RE: Value Engineering Concept #2
Rte. I-470, Jackson County,
Job No. J411650

This letter is to inform you that Emery Sapp & Sons would like to submit a Value Engineering Change Proposal involving re-designing Bridges A7503 & A7504 to single-span NU Girder structures instead of the two-span Bulb-Tee structures in the current design. The primary benefits to this proposal would be improved aesthetics and decreased construction costs.

Comments to Value Engineering Change #2
Rte. I-470, Jackson County
Job No. J4I1650

Redesign bridges A7503 and A7504 to single-span NU Girder.

SINGLE SPAN STEEL BRIDGES WITH MSE WALLS

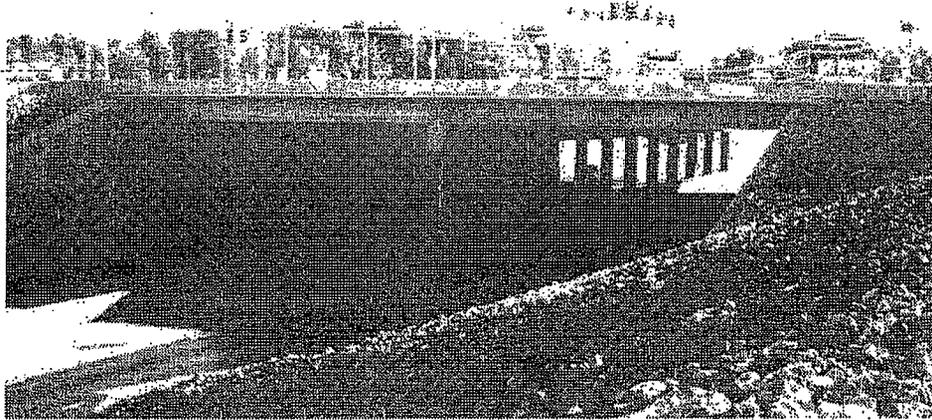
- MSE wall aesthetics.
- Shorter bridges for MoDOT to maintain and to widen.
- Greater chance of converting the interchange to a single-point in the future – geometrics to be checked then.
- MoDOT would not need to construct intermediate bents in the median of Strother Road when widening I-470.
- Roadway would have a clean and open look.
- Left turn lane(s) could be lengthened.
- Elimination of obstructions (concrete columns & barrier) in median improves roadway safety.
- Elimination of median barrier curbs and required clearances results in less pavement and increased cost savings.

Disadvantages

- Does not allow adjustment of bridge length if 2.5:1 spill slopes can be reduced.
- Widening of I-470 would require modifications to MSE walls in the median.

- MSE wall construction is not without risks (e.g. Ambassador Drive bridge project with problems related to pile driving, backfill and general fit up of panels) and walls are difficult to repair.

- Piles for widened sections of I-470 would be driven now – slight additional upfront cost and would require piles to be maintained and identified in the future.

- Limits the possibilities for widening the roadway underneath (*deemed not an issue for the Strother Road project*).
- Intersection sight distance issue (sight distance is OK for 35 mph but NW quadrant isn't for 45 mph).

- Painted steel girders will require periodic maintenance and eventual re-painting.
- Little, if any, room to locate slab drains on bridge. Drainage systems are more costly and require maintenance.

- MSE walls and I-470 widening in the median will create a tunnel effect – lighting to be addressed in the future

TWO SPAN CONCRETE BRIDGES WITH MSE WALLS

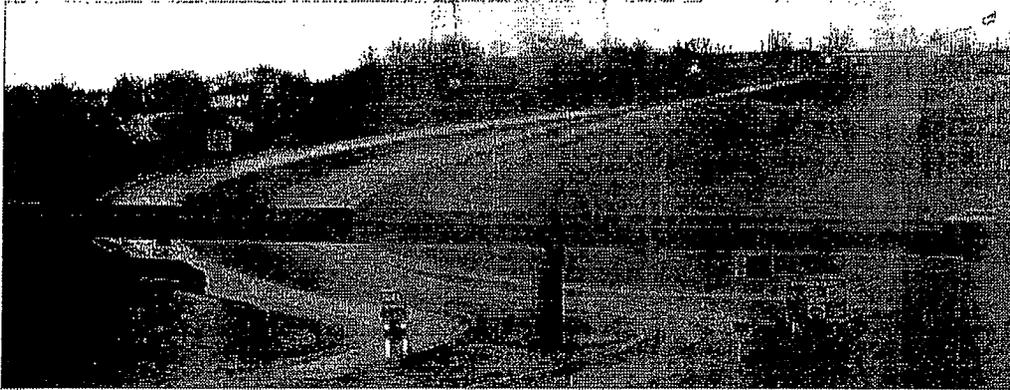
- MSE wall aesthetics.
- Shorter bridges for MoDOT to maintain and to widen.
- Concrete bridges require less maintenance.

Disadvantages

- Does not allow adjustment of bridge length if 2.5:1 spill slopes can be reduced.
- Widening of I-470 would require modifications to MSE walls in the median.

- MSE wall construction is not without risks (e.g. Ambassador Drive bridge project with problems related to pile driving, backfill and general fit up of panels) and walls are difficult to repair.

- Piles for widened sections of I-470 would be driven now – slight additional upfront cost and would require piles to be maintained and identified in the future.

- Limits the possibilities for widening the roadway underneath (*deemed not an issue for the Strother Road project*).
- Intersection sight distance issue (sight distance is OK for 35 mph but NW quadrant isn't for 45 mph).

- MoDOT would need to construct intermediate bents in the median when widening I-470.
- Concrete columns in median could be a safety issue for vehicles leaving the roadway.

- Wider median and clearances to curb & columns increase the Strother Road pavement area and increase the cost.
- Lingering issue about need & method to protect columns in the median with concrete barrier and/or increased clearances.

- Little, if any, room to locate slab drains on bridge. Drainage systems are more costly and require maintenance.
- MoDOT would need to construct intermediate bents in the median of Strother Road when widening I-470.

- MSE walls and I-470 widening in the median will create a tunnel effect – lighting to be addressed in the future
